**JUNE 5, 2019
BOARD OF COUNTY COMMISSIONERS
ORANGE COUNTY, FLORIDA
ADDENDUM NO. 2, IFB Y19-754-RC
ORANGE COUNTY FIRE RESCUE FIRE STATION #30 HVAC
REPLACEMENT**

THE REVISED BID OPENING DATE IS: JUNE 25, 2019

E-101

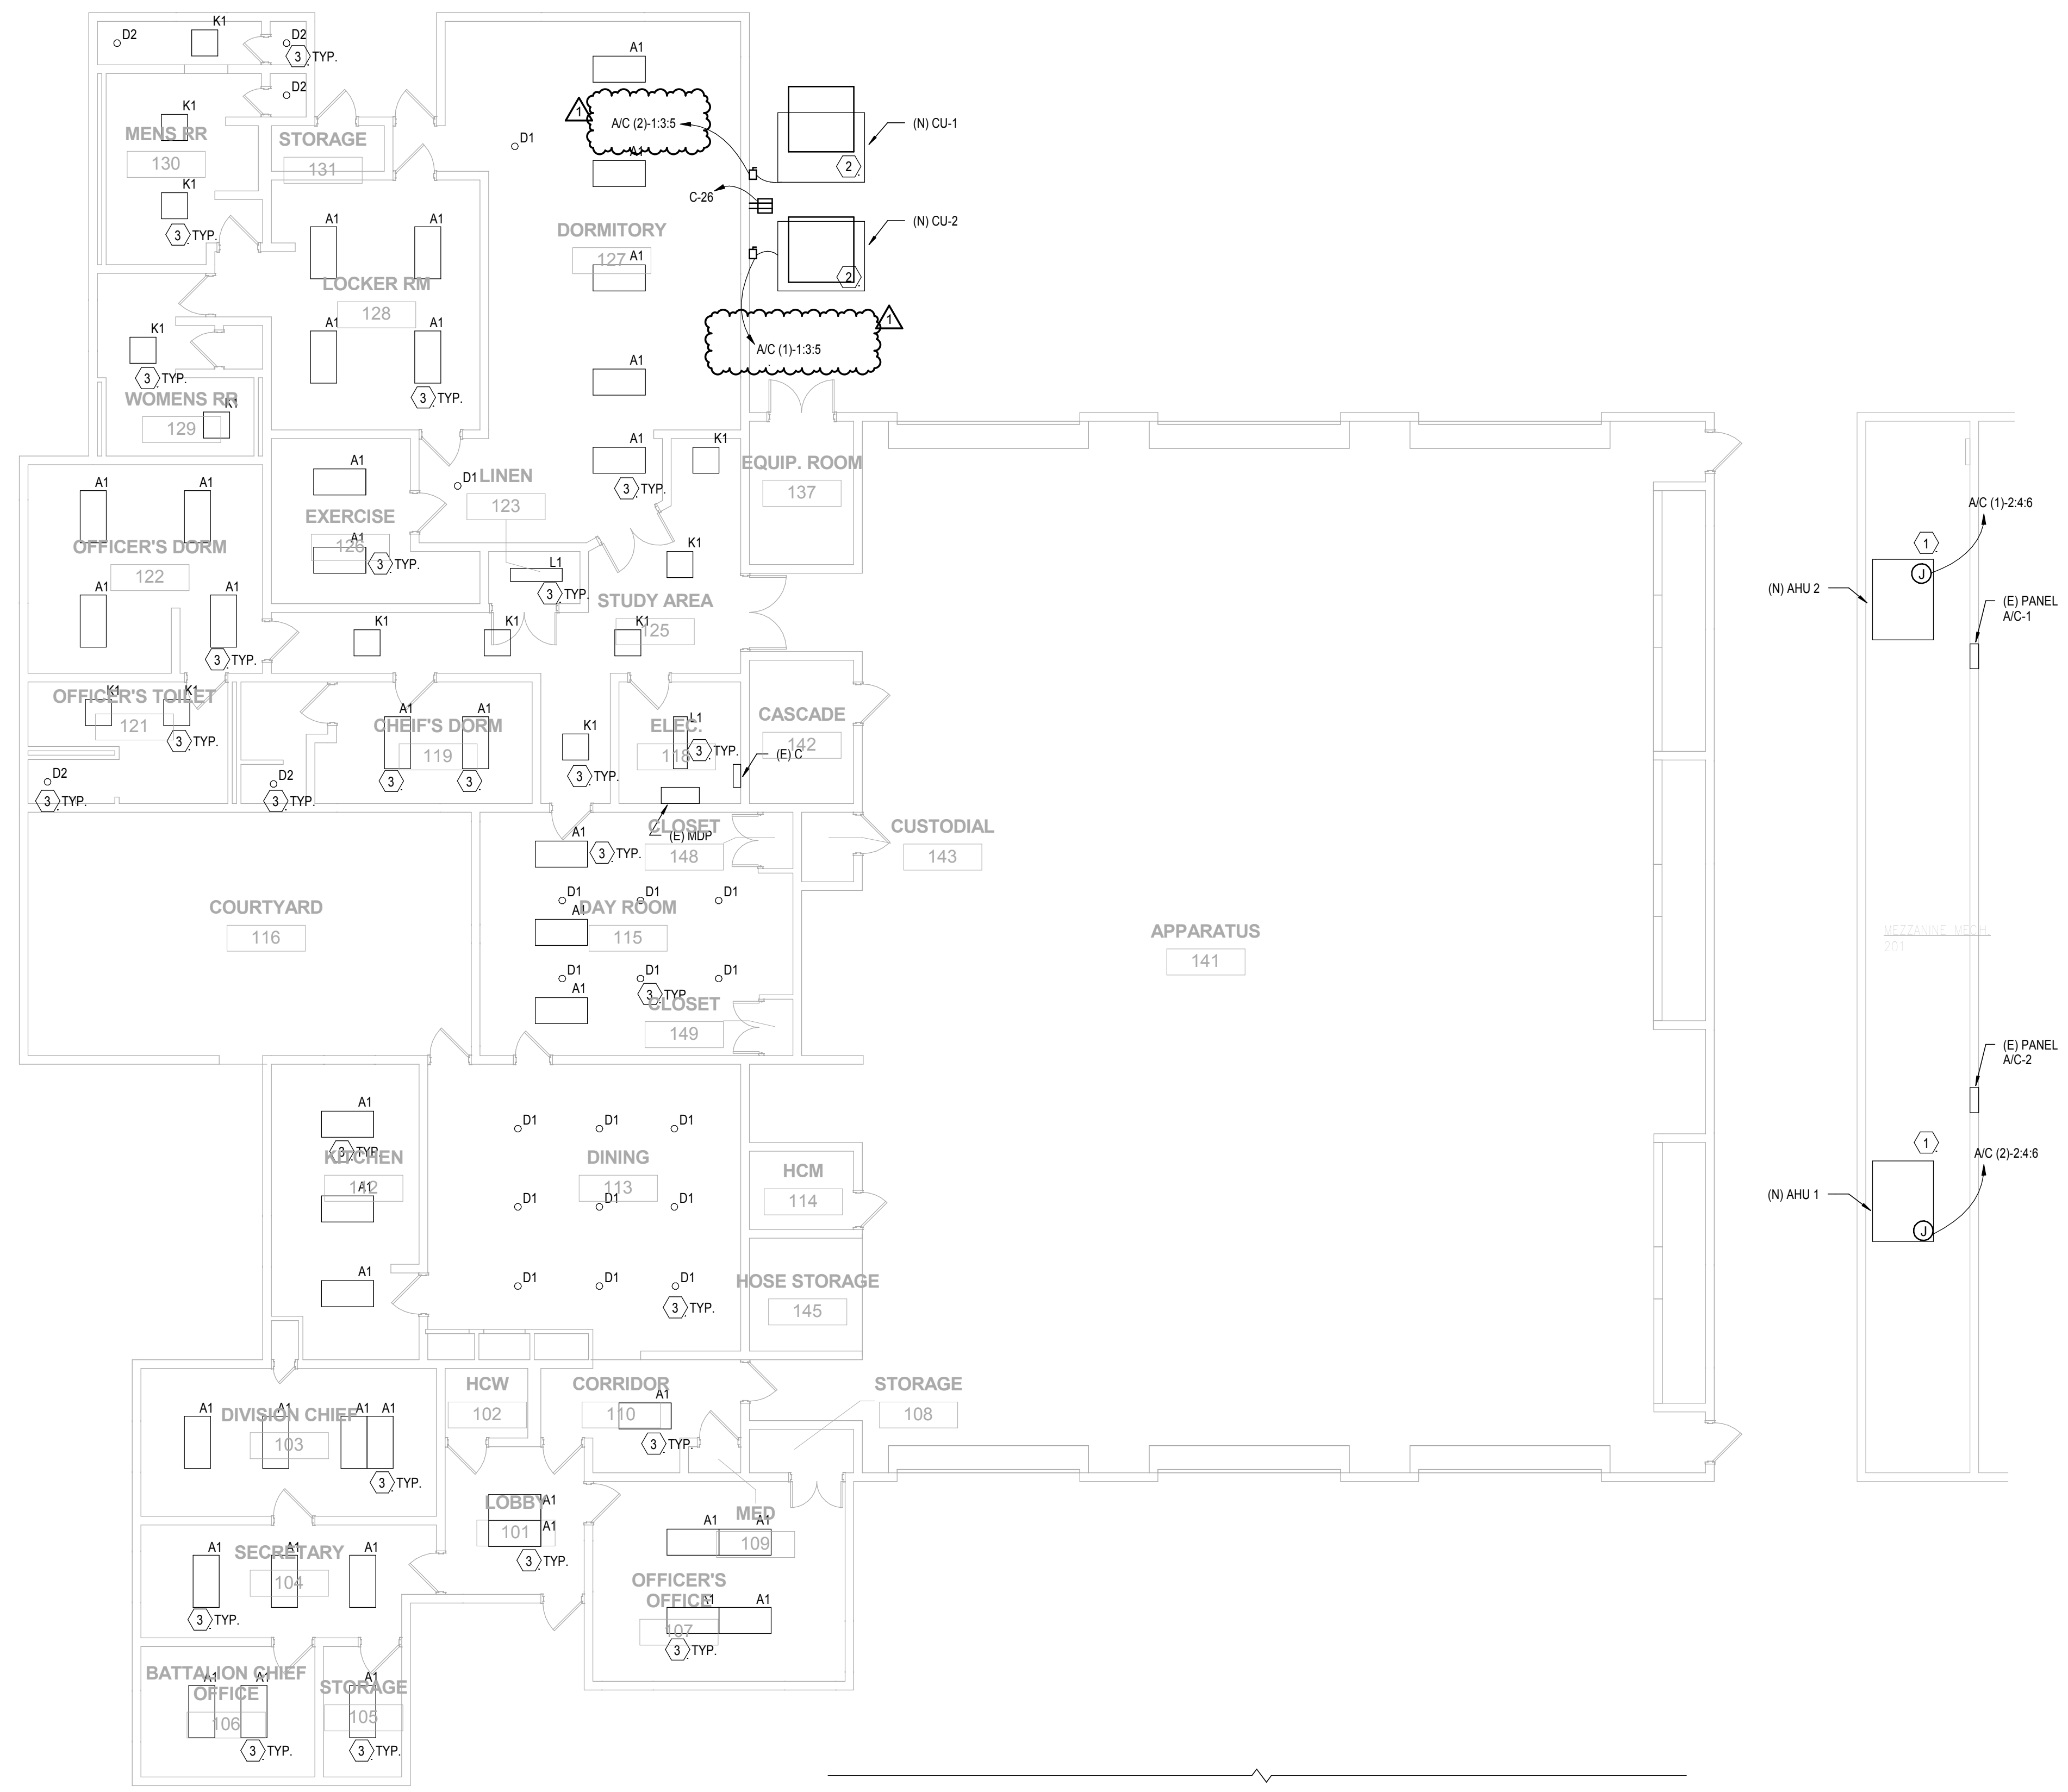
14. QUESTION: I cannot seem to find where the condensing units are being fed from. Drawings state there is an existing breaker that is to be reused but fail to show where in the building it is located. Please clarify from where the condensing units are being fed and if there is indeed an existing breaker or not.

ANSWER: Please see revised drawing sheets E-101 and E-601.

- 1. NEW AIR HANDLER WITH BUILT IN HEAT TO REPLACE EXISTING.
- 2. FOR CONDENSING UNITS, REUSE ALL DISCONNECTS AND WIRING IF IN ACCEPTABLE SHAPE AND CORRECT REQUIREMENTS BASED ON EQUIPMENT FEEDER SCHEDULE.
- 3. NEW LIGHTING TO REPLACE EXISTING. USE EXISTING FEEDERS AND BREAKERS FED FROM SAME PANEL. REFER TO LIGHTING FIXTURE SCHEDULE SHEET E-602 FOR MORE INFORMATION ON LIGHTING TYPES.

M-101

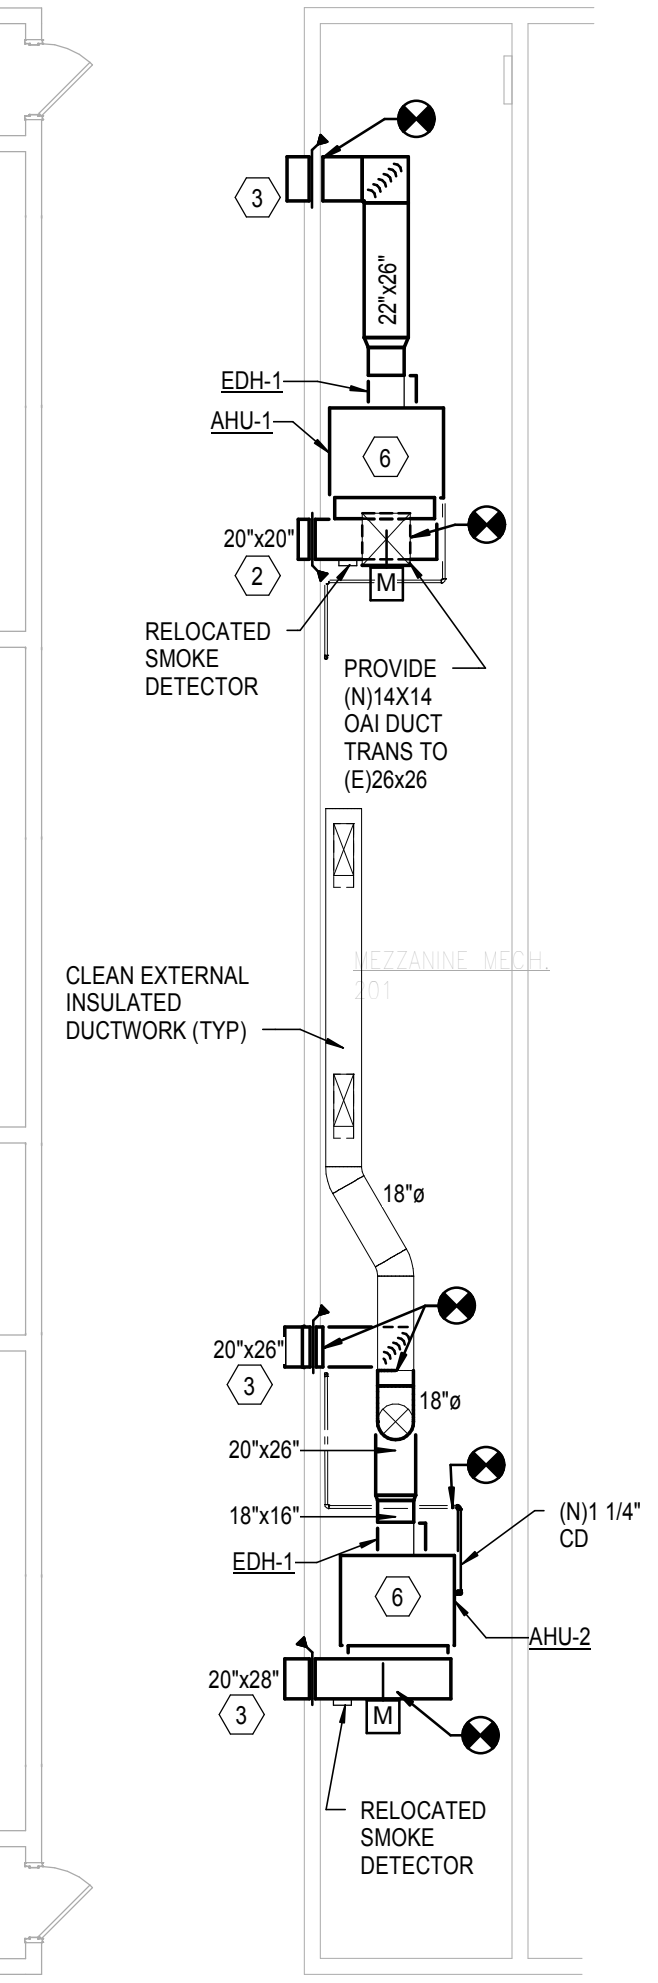
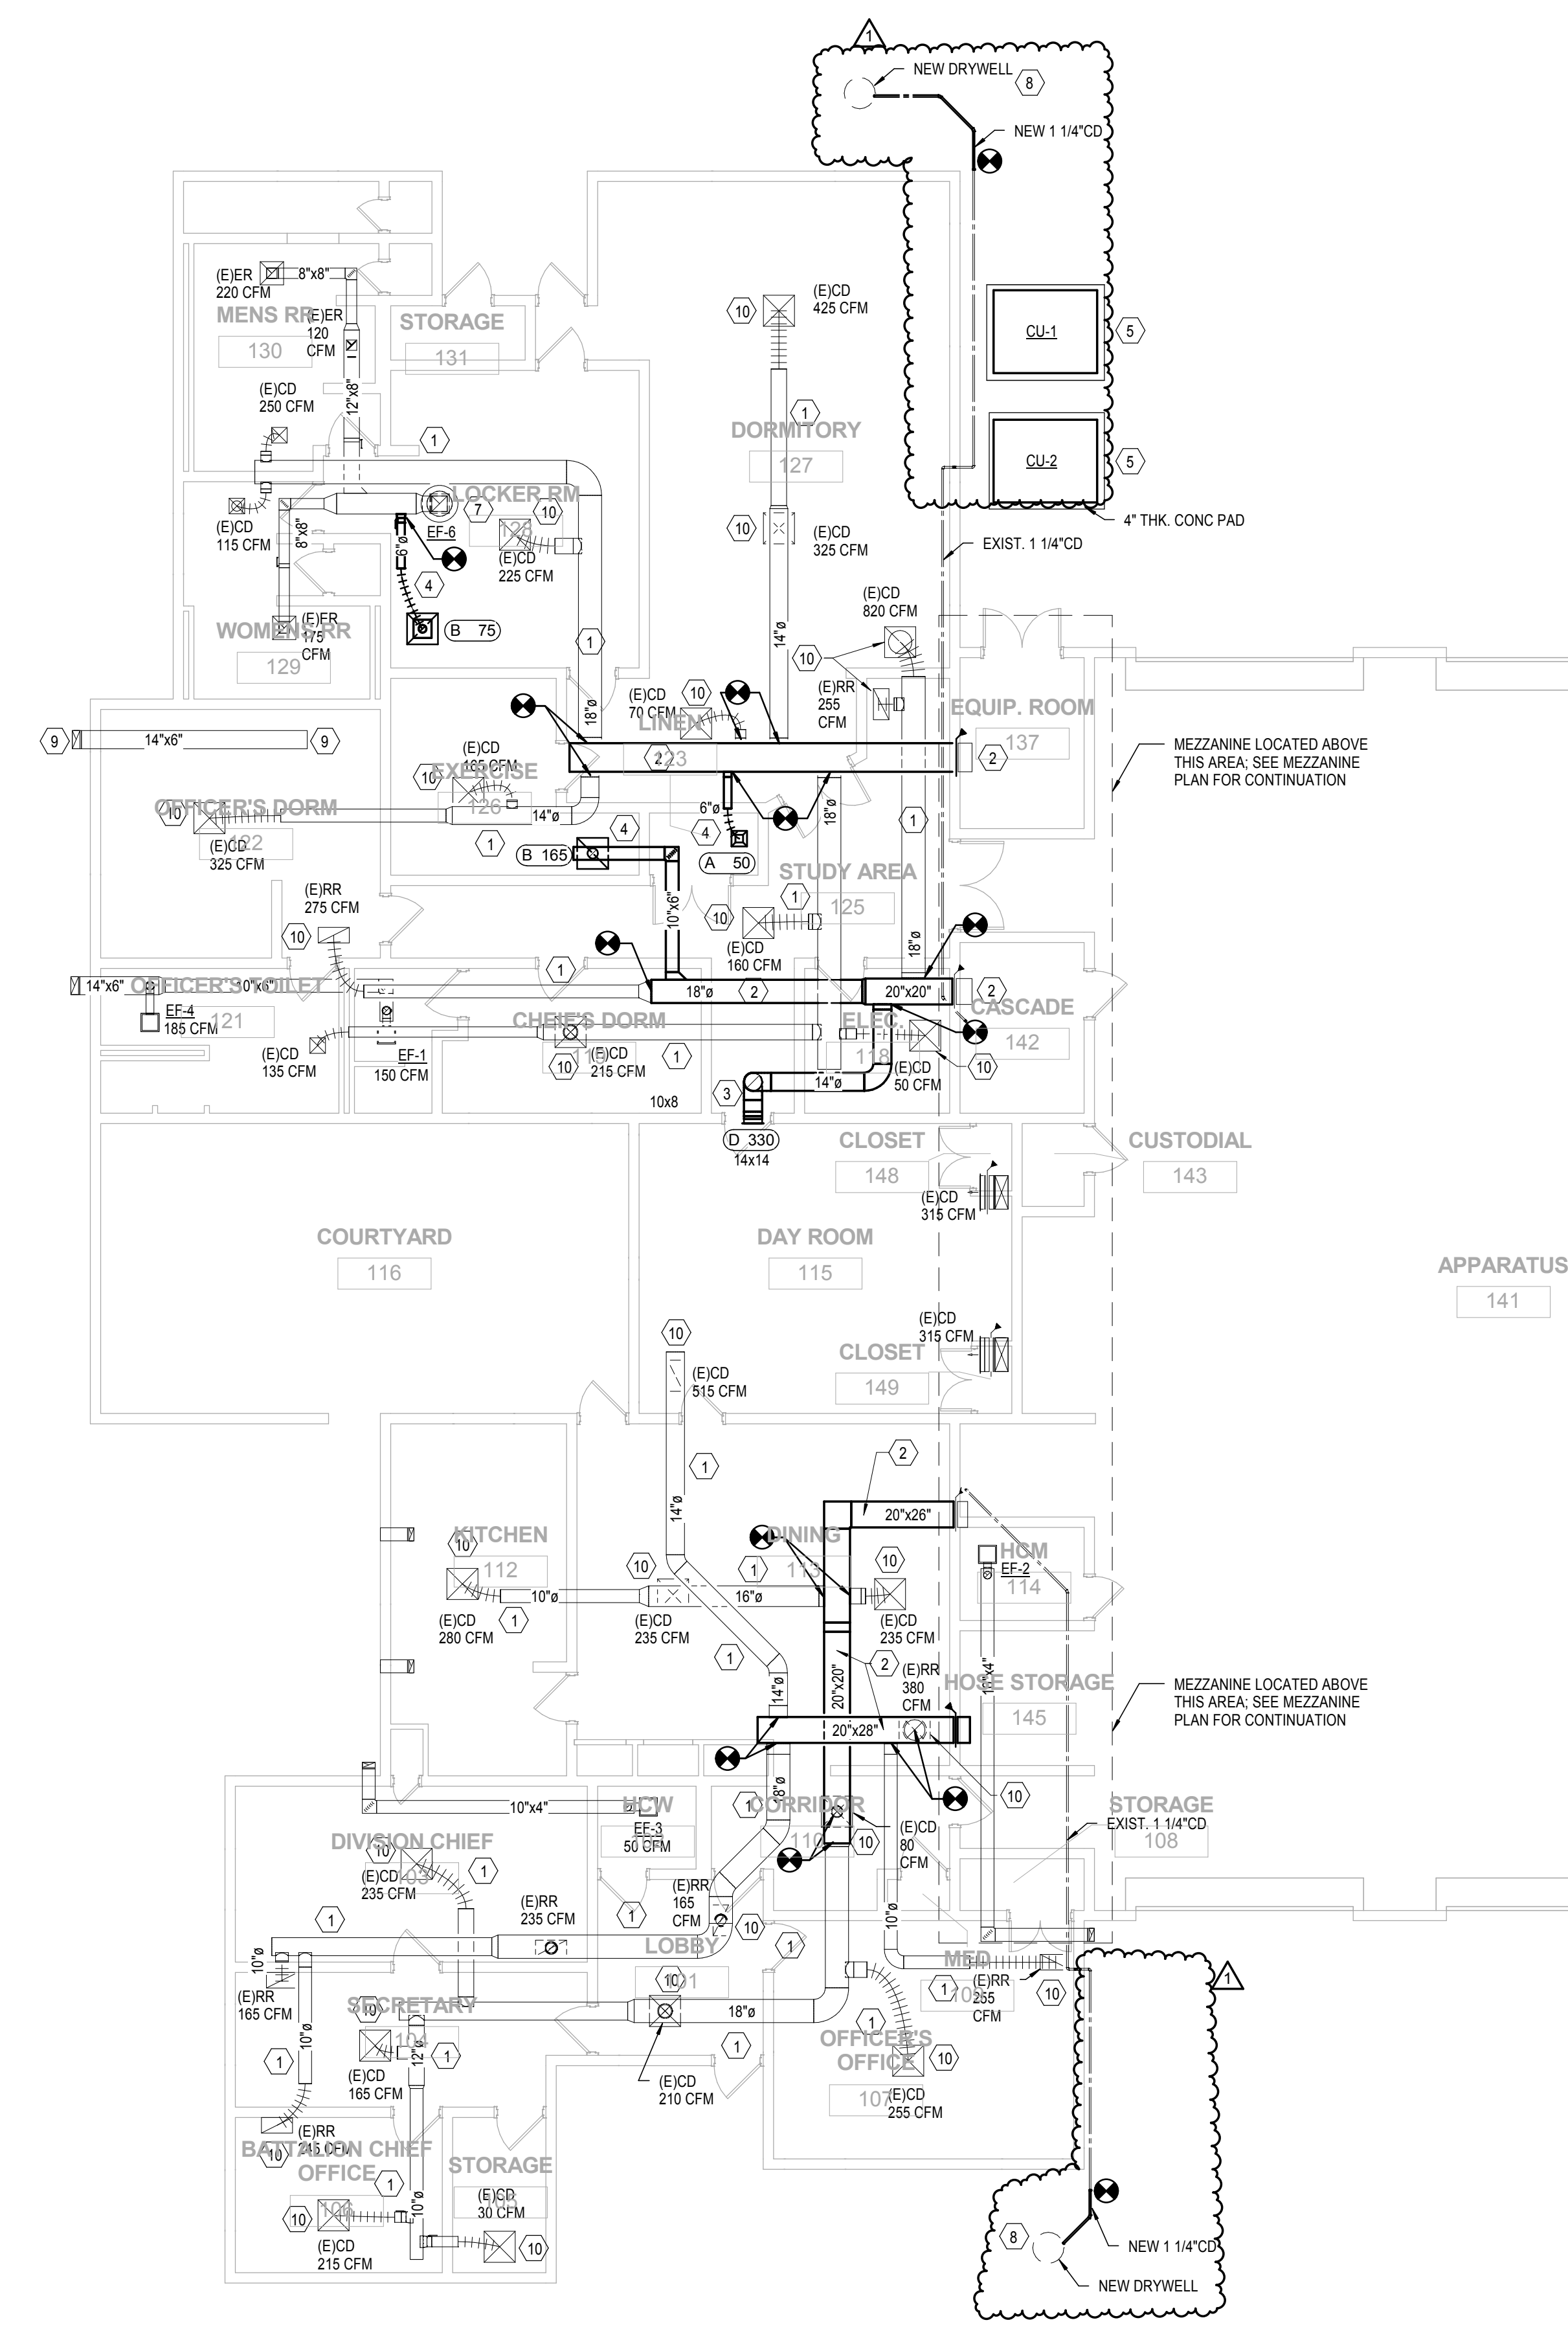
11. QUESTION: Drawing M-100, Plan Key Notes, Note #4 states to remove existing drywells and provide new. It was noticed at the Prebid meeting that from the Hastings Street entrance (east side of building) that the area indicated on the plans as the location of one of the two drywells is under an existing concrete drive way (see attached photos). Is the contractor expected to cut and remove the concrete, which will hinder the fire department from accessing that bay for an indefinite amount of time, to remove and replace the drywell then patch the concrete when finished? If so please provide a specification for that specific drywell to include DOT/traffic ratings. Please provide a detail on how to patch the concrete in this area.

12. QUESTION: For the drywell to be installed on the west side of the facility which is in a non-traffic area will the attached drywell submittal be acceptable? If not, please provide a specification.

13. QUESTION: Drawing M-101, Plan Key Notes, Note #3 states "Provide new 14" DIA. return duct and register and connect to existing return as indicated." At the #3 hex note on the Mezzanine Plan view shows only a 20"x28" and a 20"x26" duct. No 14"Ø ducts are found in this area nor are any registers shown, please clarify.

ANSWER: Please see revised drawing sheets M-100 and M-101 as well as NDS Flo-Well Drywall Spec.

ANSWER: Please see revised drawing sheets M-100 and M-101 as well as NDS Flo-Well Drywall Spec. Provide drywells in the turfed areas as shown in the revised drawings. The attached "Flo-Well" drywell is acceptable.

ANSWER: See the floor plan; a new 14"Ø duct is shown from the Dayroom returning to the main AHU-1 return duct.

- REBALANCE EXHAUST FAN TO NEW AIRFLOW; ADJUST PULLEY SQUEEZE SYSTEM TO ALLOW FOR NEW AIRFLOW.
- TIE IN TO EXISTING CONDENSATE LINE BELOW GRADE AND PROVIDE NEW DRYWELL IN TURFED AREA. EXCAVATE BY HAND AS REQUIRED TO AVOID DAMAGE TO EXISTING UTILITIES.
